Oxford City Planning Committee Presentation

21/01695/FUL

Thornhill Park

13th December 2022

First floor plan

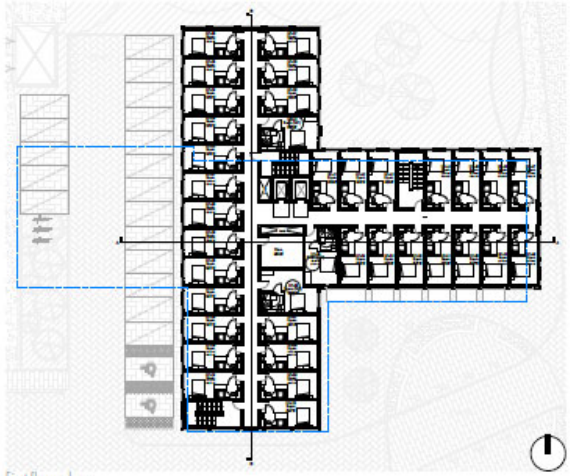
133 hotel rooms - no change to the number of rooms

Following extensive consultation it was agreed to step the Hotel building further away from the western boundary of the site and reduce the hotel to a maximum of 4 storeys to reduce the impact on existing neighbouring residential. The design of the elevations were considered in further detail with a comparison between the two schemes presented on the following pages. In addition, the brick tone was reviewed to provide a more subdued, lighter brick to provide a backdrop when viewed from Downside End.

Block E - Proposed Scheme

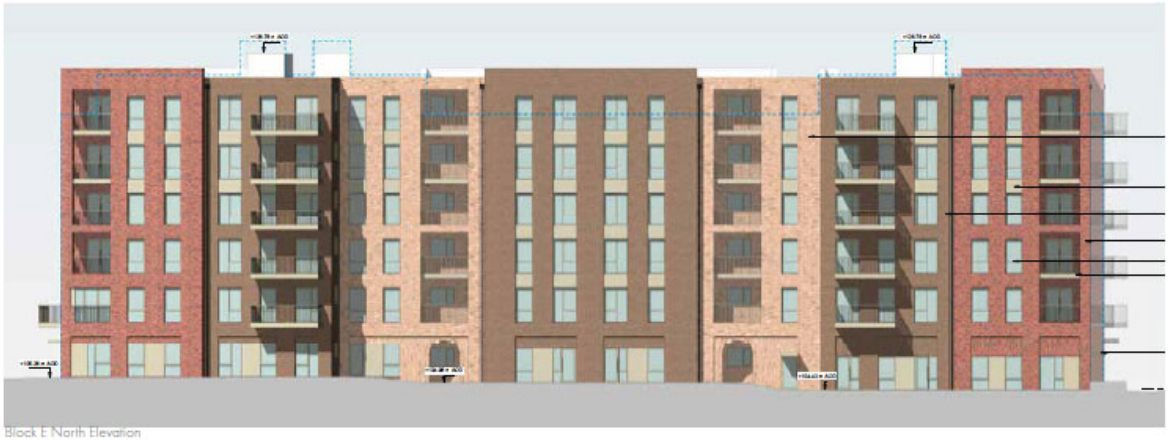
146 homes - an increase of 14 homes

All the ground floor flats have direct, external access so this does not require any change.

Due to the reduction in homes elsewhere and the policy requirement to require 400 homes on the site, Block E, has increased its number of homes. Block E is at the centre of the site with no impact on existing neighbours. The fifth floor has become a full floorplate rather than a set back upper storey. This means there is no increase in maximum storey heights of the building.

Block F - Proposed Scheme

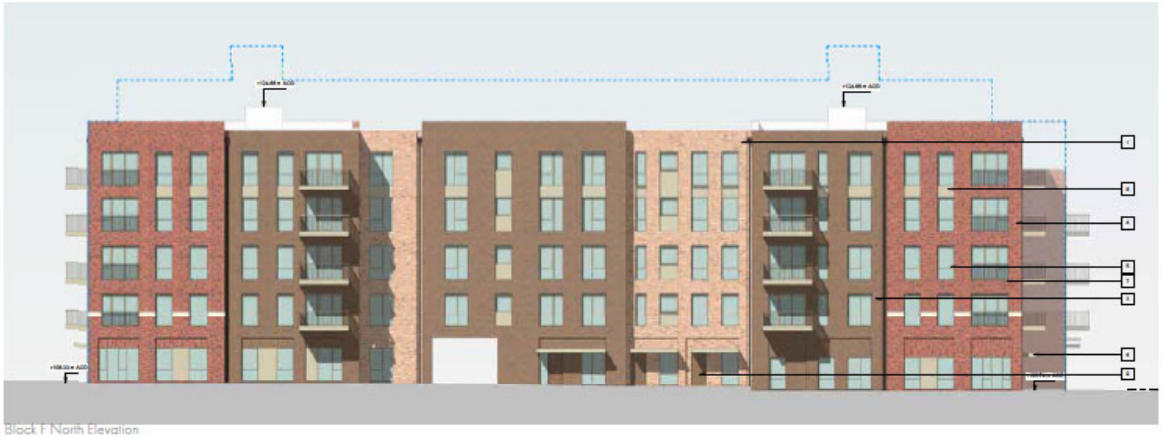
112 homes - a reduction of 12 homes and removal of rooftop amenity

All the ground floor flats have direct, external access so this does not require any change.

The full typical floor and the rooftop shared amenity have both been removed. In addition the parapet height has been minimised where feasible while retaining the architectural intent of the building.

While the fourth floor retains the set back to the south as previously proposed on the upper floor, the northern edge has been extended to the edge of the typical floorplate. This simplifies the building form.

In addition the northern units have been redesigned to increase the number of homes per floorplate. This does increase the number of single aspect north facing units however these have been designed to ensure these homes are 1 bedroom only.

Block G - Proposed Scheme

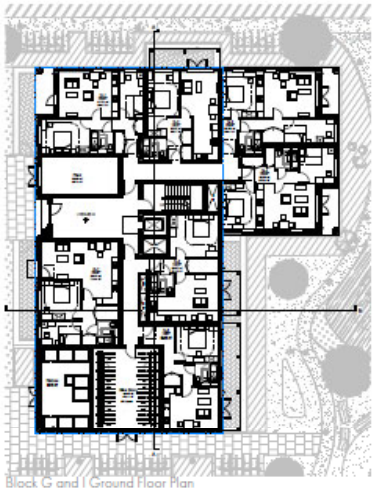
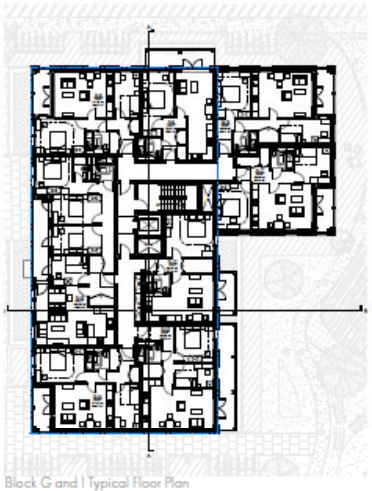
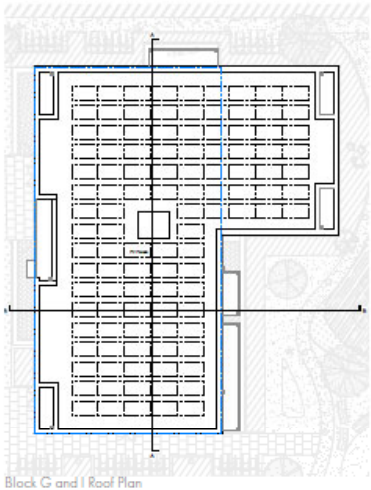
31 homes - an incease of 2 homes

One floor has been removed and the parapet height reduced to minimise the impact on the open space to the east of the site. In addition the floorplate has been redesigned to replace the lost units while framing the northern edge of the public amenity space.

The appearance of the balconies has been softened and reduced while retaining the architectural principles of the building. All balconies can be accessed from the living space of the apartment.

Block H - Proposed Scheme

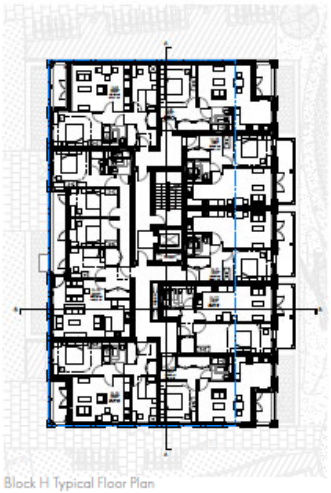
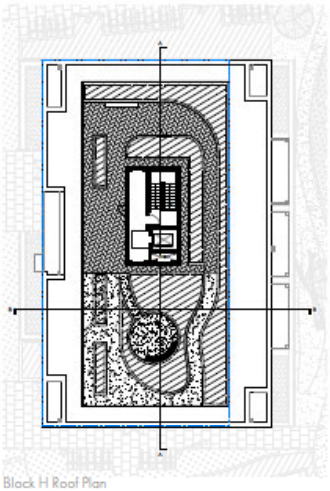
31 homes - an incease of 2 homes

One floor has been removed and the parapet height reduced to minimise the impact on the open space to the east of the site. Rooftop amenity has been provided on this building to replace the shared amenity lost on Building F.

In addition the floorplate has been widened and redesigned to replace the lost units from the upper floor.

The appearance of the balconies has been softened and reduced while retaining the architectural principles of the building. All balconies can be accessed from the living space of the apartment.

Block I - Proposed Scheme

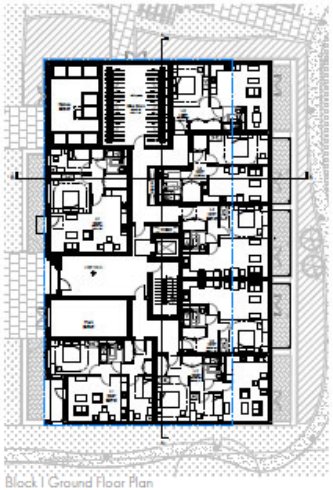
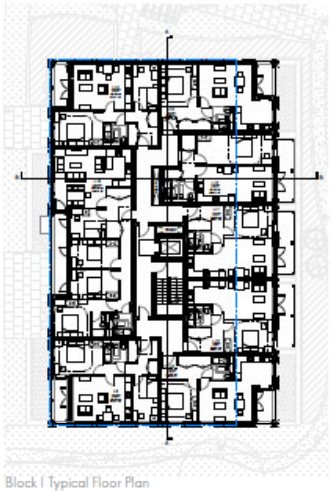
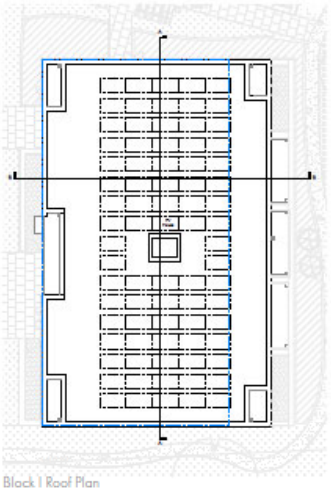
31 homes - an incease of 2 homes

One floor has been removed and the parapet height reduced to minimise the impact on the open space to the east of the site.

In addition the floorplate has been widened and redesigned to replace the lost units from the upper floor, in the same manner as for Block H.

The appearance of the balconies has been softened and reduced while retaining the architectural principles of the building. All balconies can be accessed from the living space of the apartment.
